Access Compliance Report

Public Rights-of-Way

| Intersection ID: 28929 | Main Street: WADE_ARDREY_RD | Cross Street: CAMPBELL_HALL_CT | Location: NE |
| ADA ID: 77763FCF4C20 | Ramp Type: Perp | Initial Pass/Fail: Fail | Overall Compliance: No |

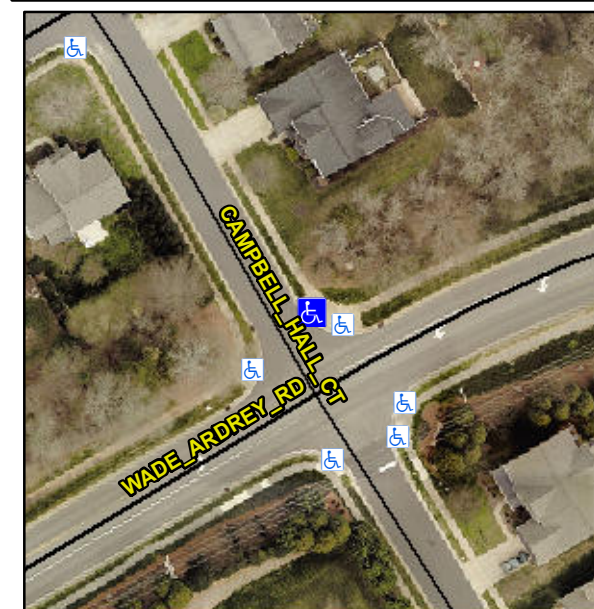
| Compliance | Description | Data | Compliance | Description | Data |
|------------|-----------------------|-------|------------|-----------------------------|------|
| No | Ramp Width (in) | 33.0 | Yes | Ramp XSlope (%) | 0.4 |

Remove & Replace Entire Ramp.

R304.5.1
